Access Compliance Report

Public Rights-of-Way

(Curb Ramps)

Intersection ID: 52453	Main Street: PAT_GARRETT_ST	Cross Street: DOUBLE_OAKS_RD	Location: NE
ADA ID: D17A3FD8B9FD	Ramp Type: Perp	Initial Pass/Fail: Fail	Overall Compliance: No
Severity Score: 12.5			
Codes/Mitigation Info/Possible Solution		Field Measurements/Component Compliance

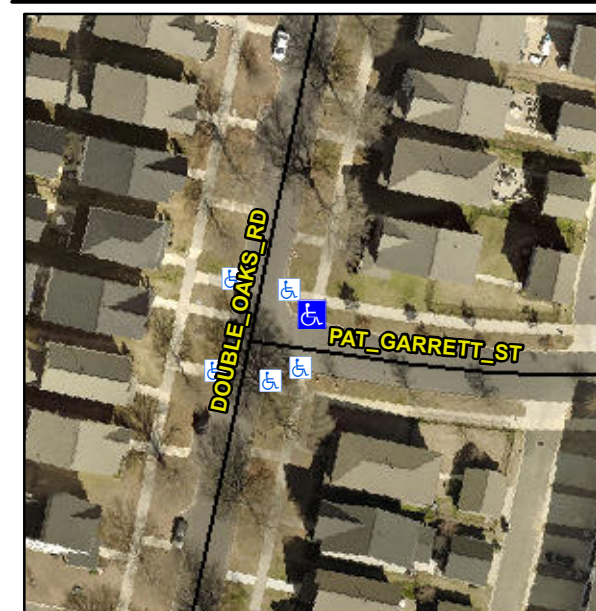
Compliance	Description	Data	Compliance	Description	Data
N/A	Ramp Length (in)	102.0	No	Ramp Slope (%)	11.3
Yes	Ramp Width (in)	67.0	Yes	Ramp XSlope (%)	1.2
N/A	Flare Type LT	N/A	N/A	Flare Type RT	N/A
N/A	Flare Slope LT (%)	N/A	N/A	Flare Slope RT (%)	N/A
N/A	Flare Traversable LT?	N/A	N/A	Flare Traversable RT?	N/A
N/A	Landing Length (in)	N/A	N/A	DWS Provided?	N/A
N/A	Landing Width (in)	N/A	N/A	DWS Contrast?	N/A
N/A	Landing Slope (%)	N/A	N/A	DWS Length (in)	N/A
N/A	Landing X Slope (%)	N/A	N/A	DWS Full Width?	N/A
N/A	Landing Curb? (Y/N)	N/A	N/A	DWS Offset (in)	N/A
N/A	Shared Landing?	N/A			
N/A	Gutter Ponding?	N/A	N/A	Gutter Slope (%)	N/A
N/A	Gutter Lip Ht (in)	N/A	N/A	Gutter X Slope (%)	N/A
N/A	Painted X Walk1?	No	N/A	Painted X Walk2?	N/A
	X Walk 1 Direction	To S		X Walk 2 Direction	N/A
N/A	X Walk 1 Width (in)	N/A	N/A	X Walk 2 Width (in)	N/A
	X Walk 1 Slope (%)	2.1		X Walk 2 Slope (%)	N/A
	X Walk 1 X Slope (%)	1.8		X Walk 2 X Slope (%)	N/A

Remove & Replace Entire Ramp.

R304.2.2
